**DEPARTMENT OF TRANSPORTATION
STATE OF GEORGIA**

SUBJECT APPROVED REVISED CONCEPT REPORT

**DEPARTMENT OF TRANSPORTATION
STATE OF GEORGIA
REVISED PROJECT CONCEPT REPORT**

Project Type:	<u>Intersection Improvement</u>	P.I. Number:	<u>0006932</u>
GDOT District:	<u>District 7</u>	County:	<u>Rockdale</u>
Federal Route Number:	<u>N/A</u>	State Route Number:	<u>N/A</u>
Project Number:	<u>STP-0006-00(932)</u>

ROUNDBOUT CONCEPT REVISED

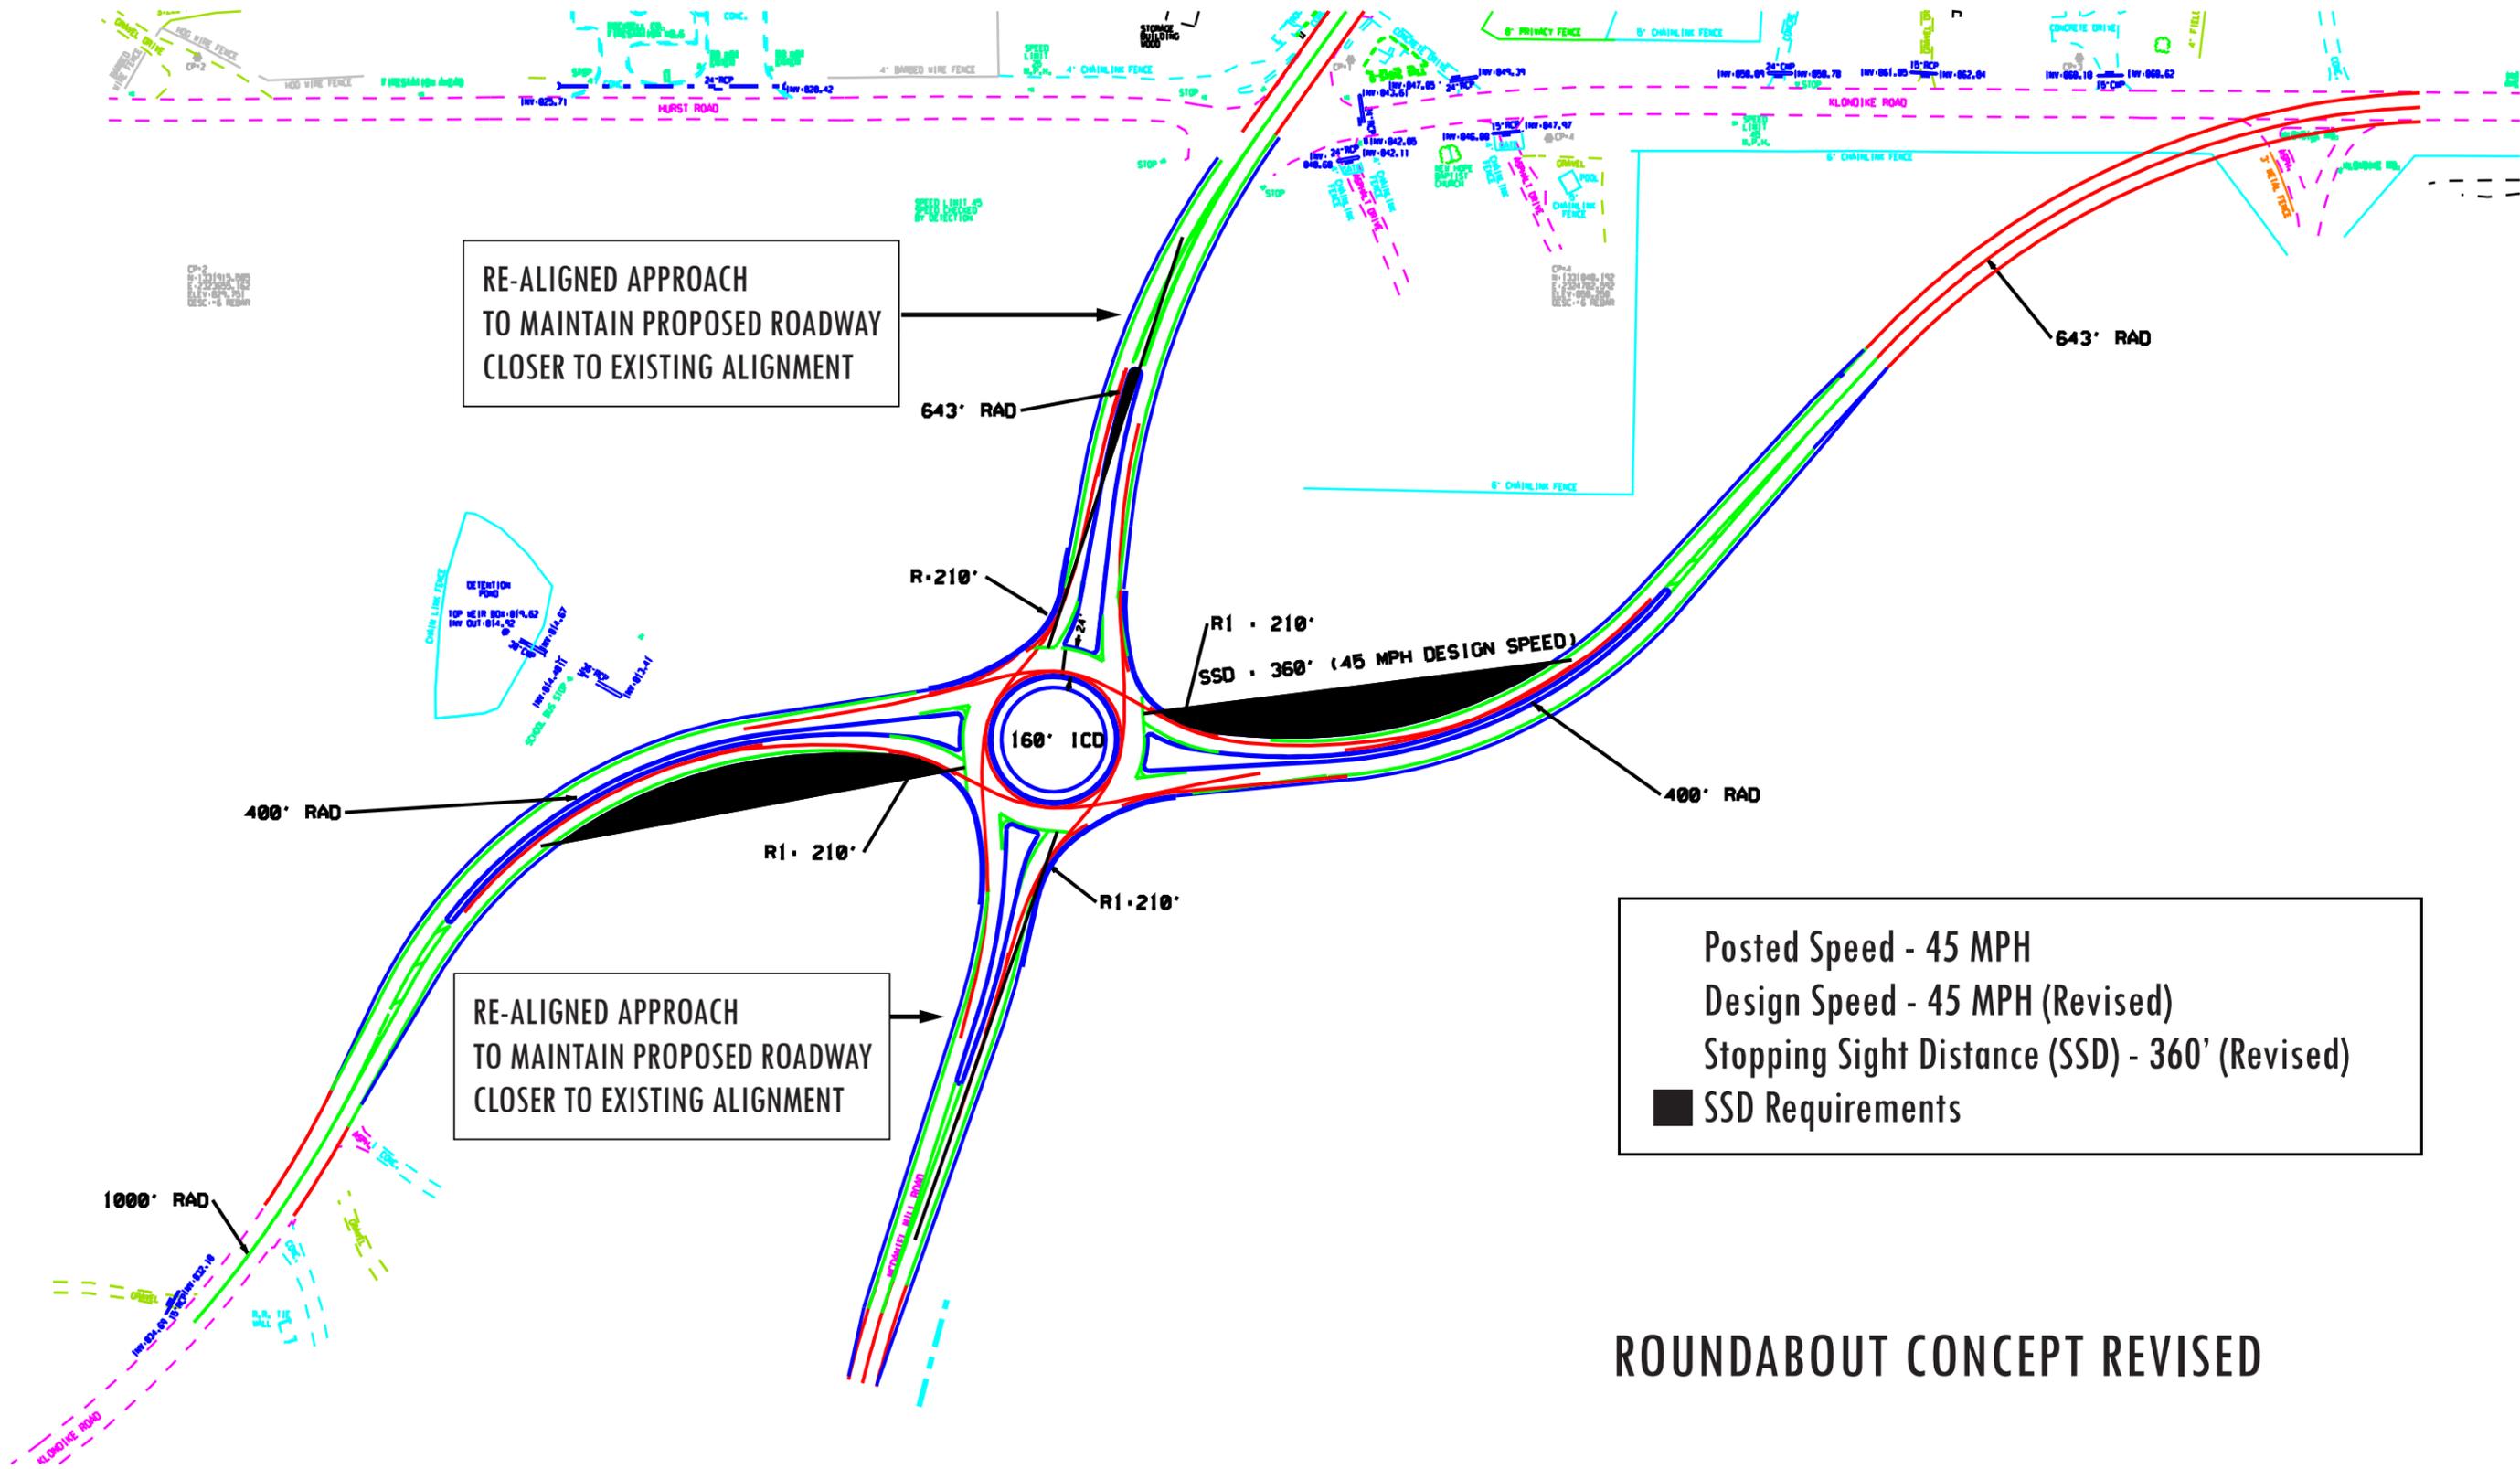
Posted Speed - 45 MPH
 Design Speed - 45 MPH (Revised)
 Stopping Sight Distance (SSD) - 360' (Revised)
 ■ SSD Requirements
